SUBJECT: Final (100%) Remedial Design for LHAAP-47, Plant 3 Area, Solid Rocket Motor Fuel Production, Longhorn Army Ammunition Plant, Karnack, Texas

Comments Response Matrix
30% Remedial Design, LHAAP-47, Plant 3 Area, Solid Rocket Motor Fuel Production,
Longhorn Army Ammunition Plant, Karnack, Texas Submitted: May 14, 2025

Comments Response Matrix
60% Remedial Design, LHAAP-47, Plant 3 Area, Solid Rocket Motor Fuel Production,
Longhorn Army Ammunition Plant, Karnack, Texas Submitted: December 2, 2025

Comments Response Matrix
Draft 100% Remedial Design, LHAAP-47, Plant 3 Area, Solid Rocket Motor Fuel Production,
Longhorn Army Ammunition Plant, Karnack, Texas Submitted: April 21, 2026

FIGURE 1-2

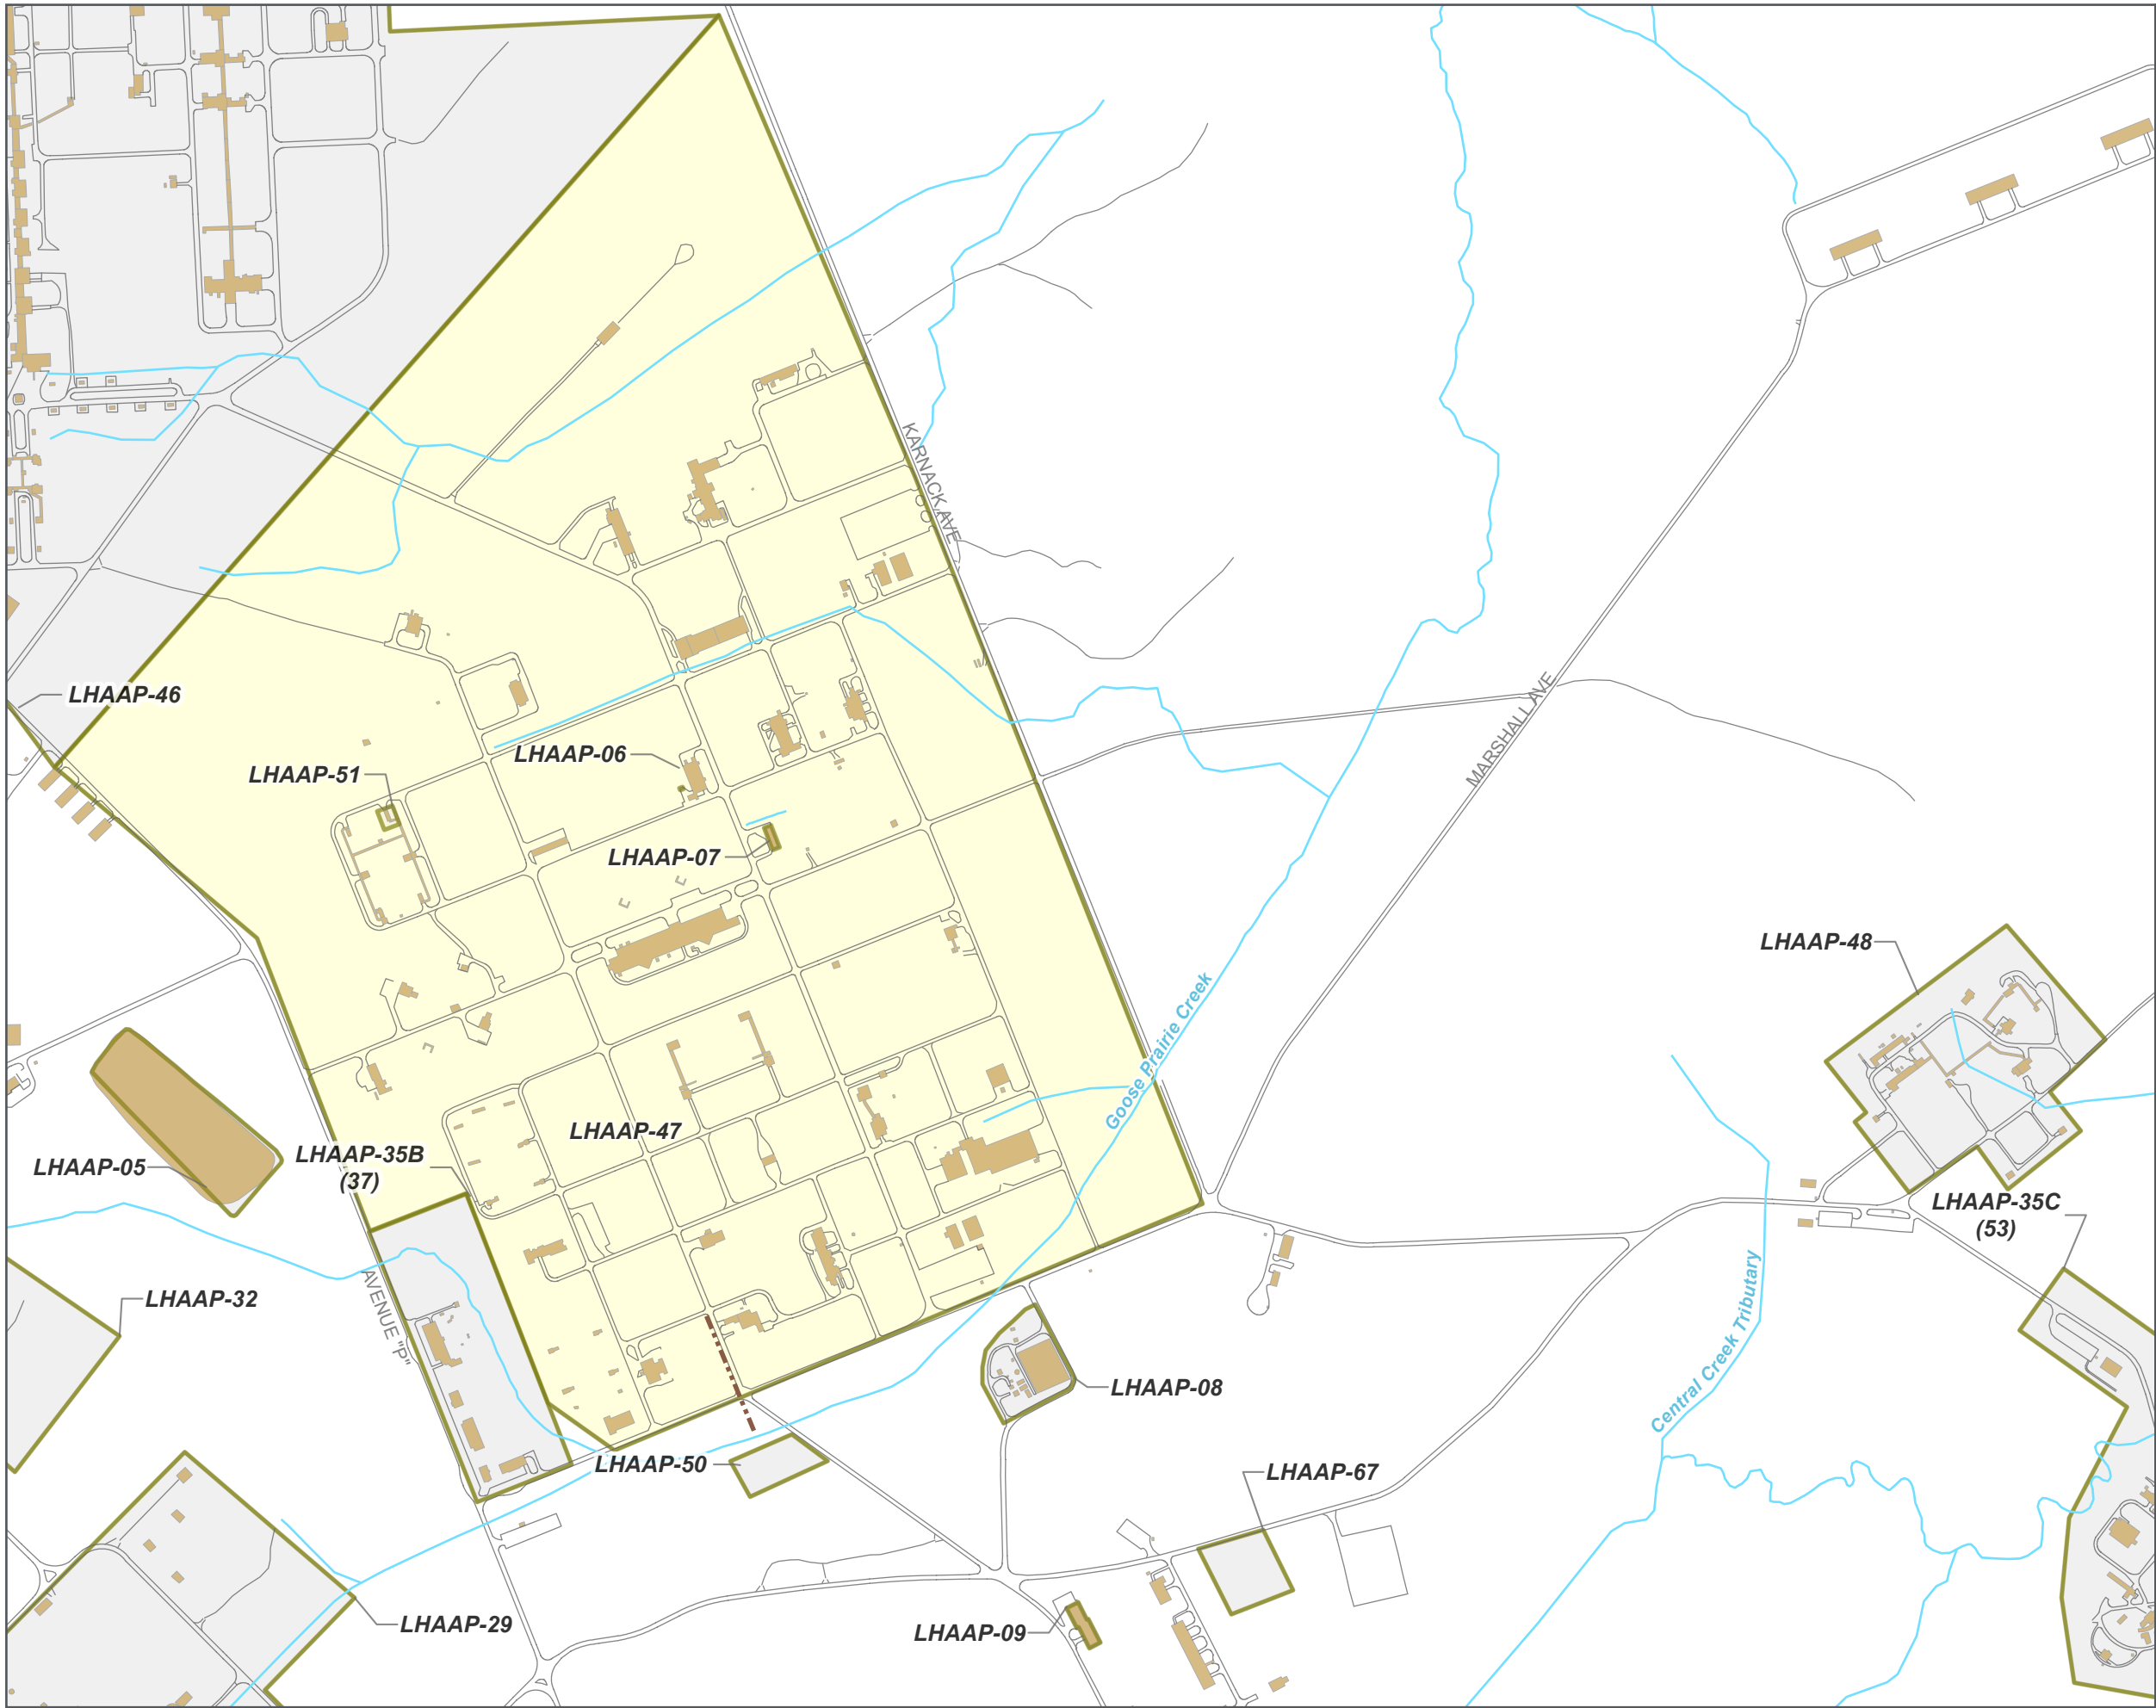
20.	5.3.5/ 5-4	1 st /1 st & 6 th lines	Add TCEQ.	C	In Draft (100%) Design Analysis Report, Section 5.3.5, Text was revised to include “TCEQ”.	
21.	Figures and Tables	Figure 1-2	It would be better to remove the USFWS Refuge boundary from this figure and include another figure that shows all the LHAAP Army owned and CLNWR transferred property. I think the intent of the green border is to show the groundwater impacts are still within Army property but that isn’t clear from this figure. You only have the incomplete border relative to LHAAP-47 (rather than shading and depicting all transferred property). There are other Army-controlled units within the scale of this figure.	C	Concur. Figure 1-2 was revised to reflect LHAAP Army owned and CLNWR transferred property as well as the LHAAP-47 boundary.

FIGURE 5-1

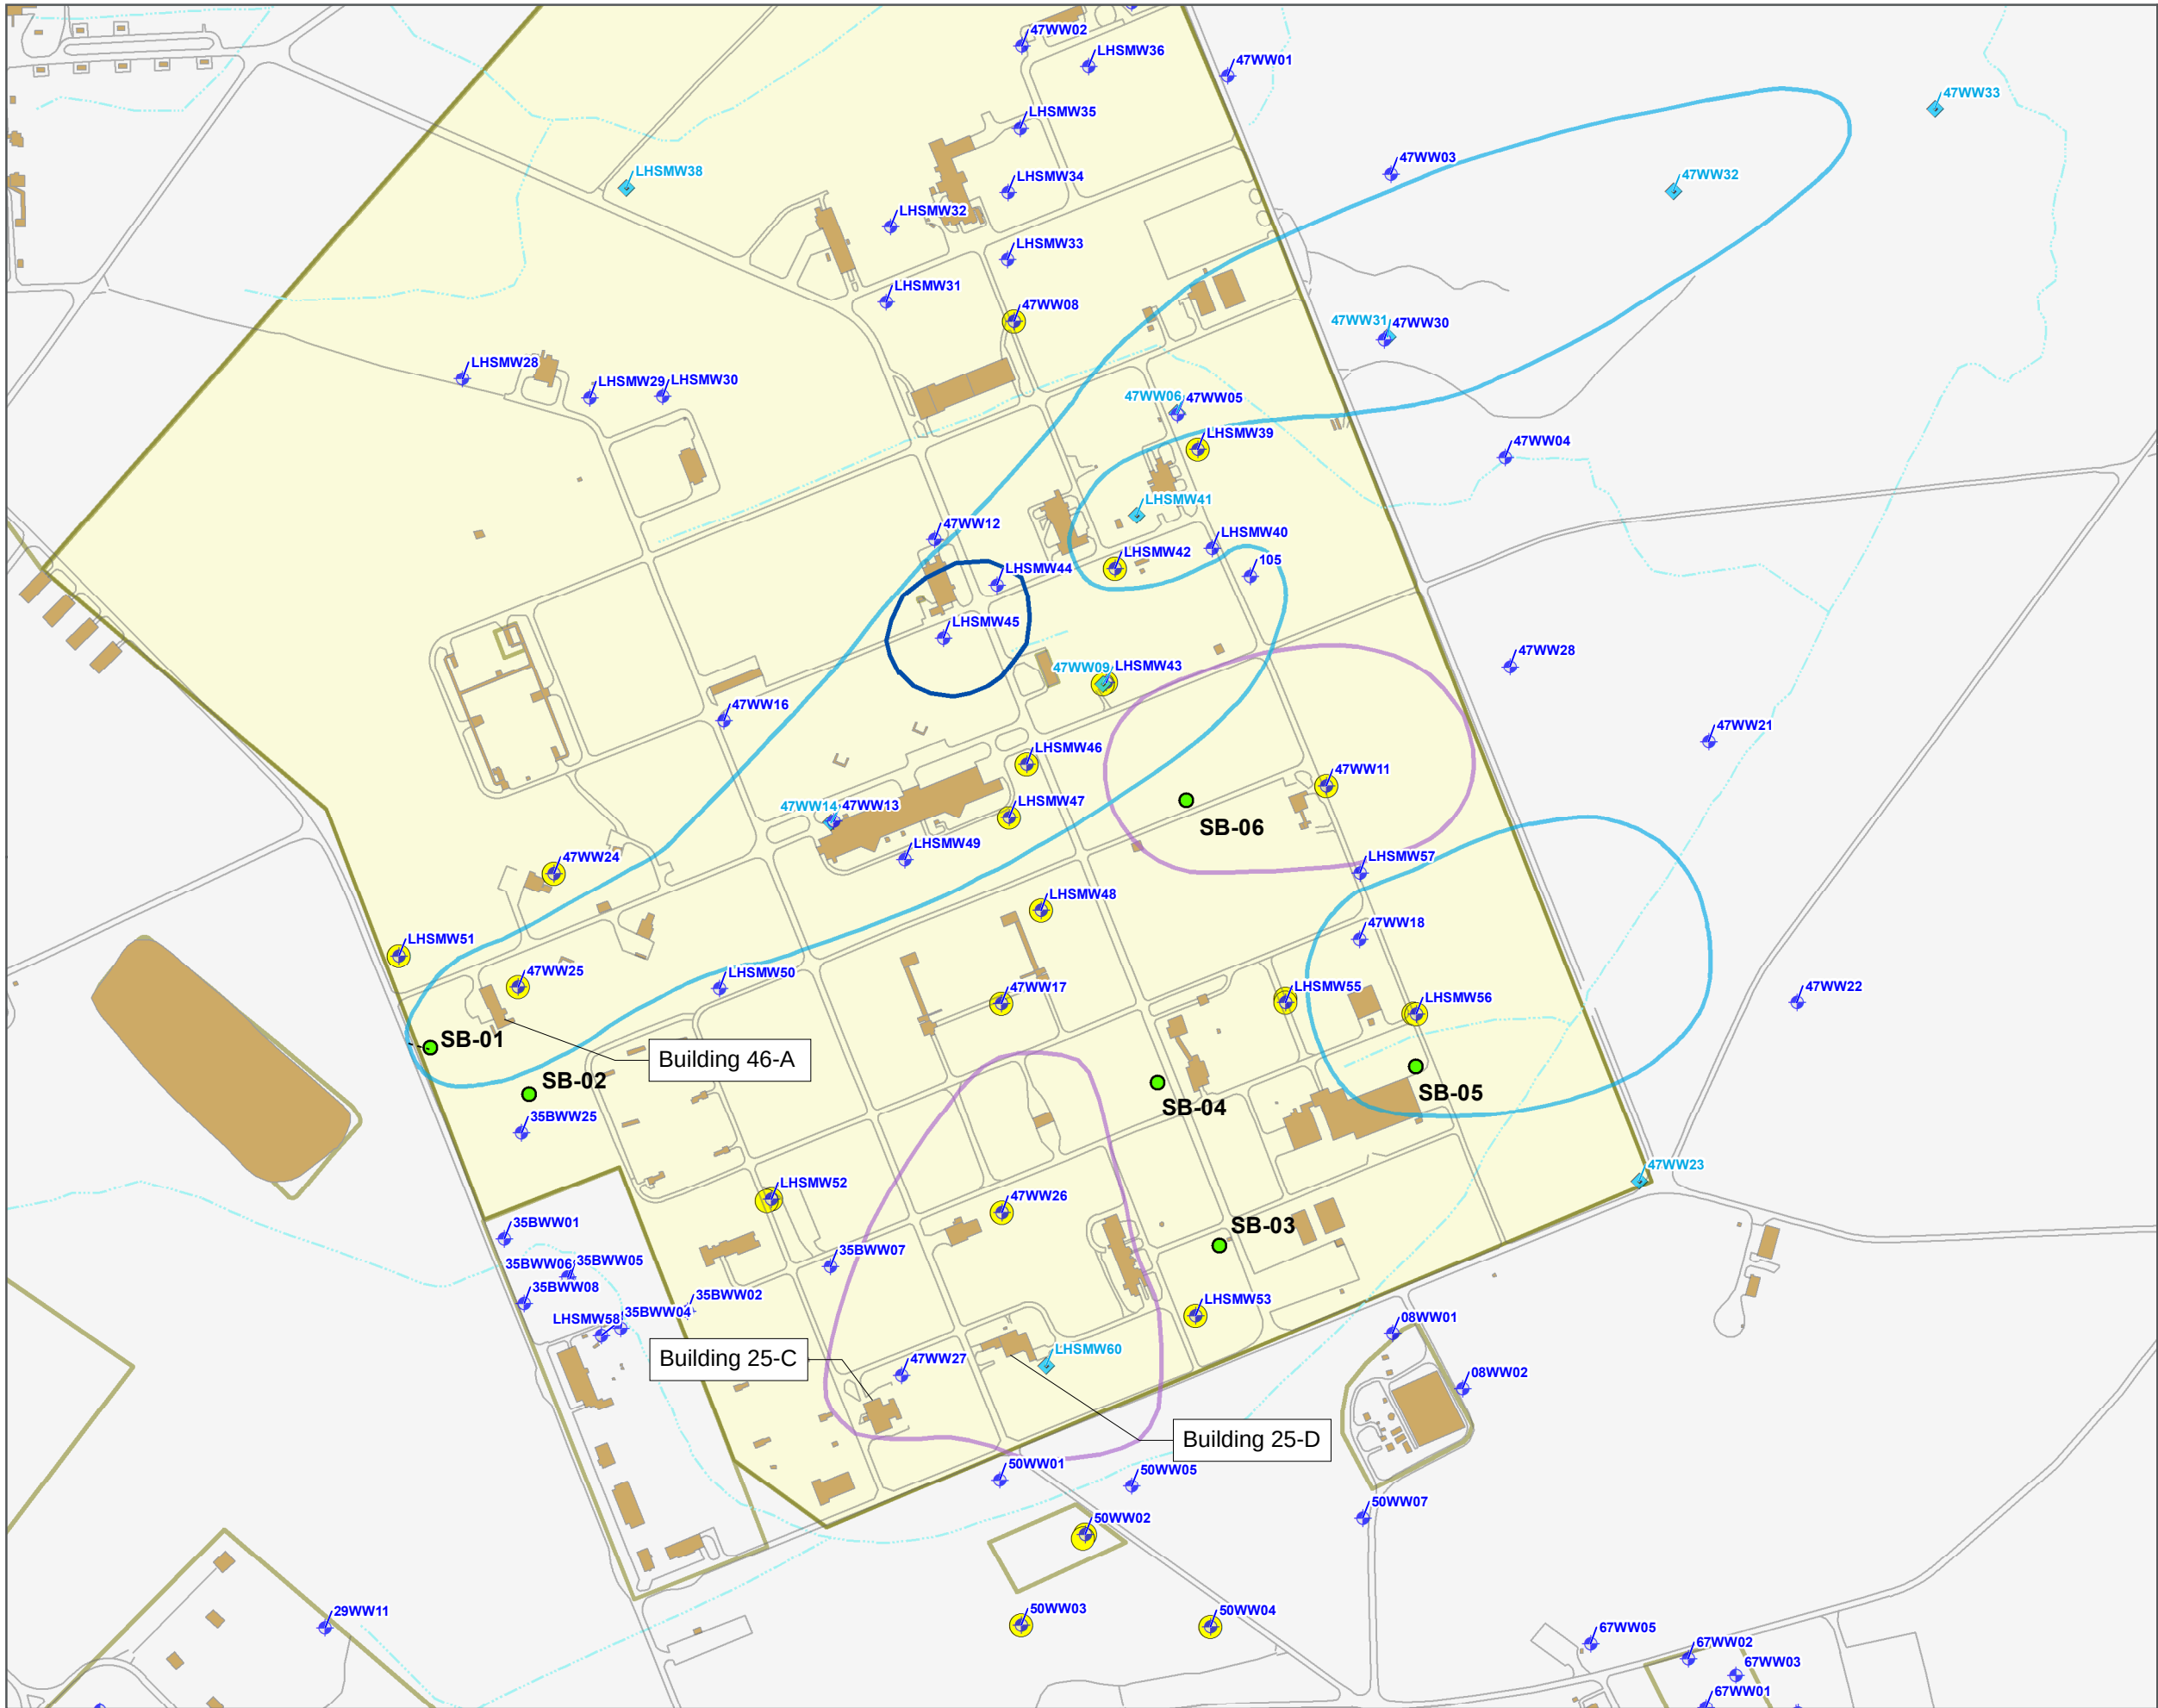
Number	Section/Page	Paragraph/Line	Comment	C,D	Response	A,D
7.	2/ 2-1	All of it	Add Figure 5-1 from the 2011 FS to show the excavation areas and reference that figure in this section. It would help if the areas were labeled to match the bullets. We are sharing an example. Figure 2-7 from the ROD does not include the FS excavation areas. Anywhere the term “condensed” is used, replace with “combined”. Some of the specific excavation areas included in the 2011 FS will be combined into one excavation area. First sentence of paragraph after the bullets, revise to this (or similar): The subsequent phases of PDI did not include soil samples in this area so there are no changes from the FS phase.	C	Figure 5-1 is included in Appendix C and the text has been revised as follows, “The FS identified unsaturated contaminated soil located near the former Building 25C (Figure 2-7 of Appendix C) containing perchlorate concentrations that exceeded the GWP-Ind standard. Based on the exceedances, eight excavation areas were initially identified in the FS (Figure 5-1 of Appendix C).” The text has been revised to state, “The subsequent phases of the PDI did not collect any soil samples. Therefore, the extent of areas for soil excavation were estimated based on the data provided in the Final FS (Shaw, 2011). The above eight excavation areas were combined into five excavation areas based on the delineating method described in Section 2.2.”
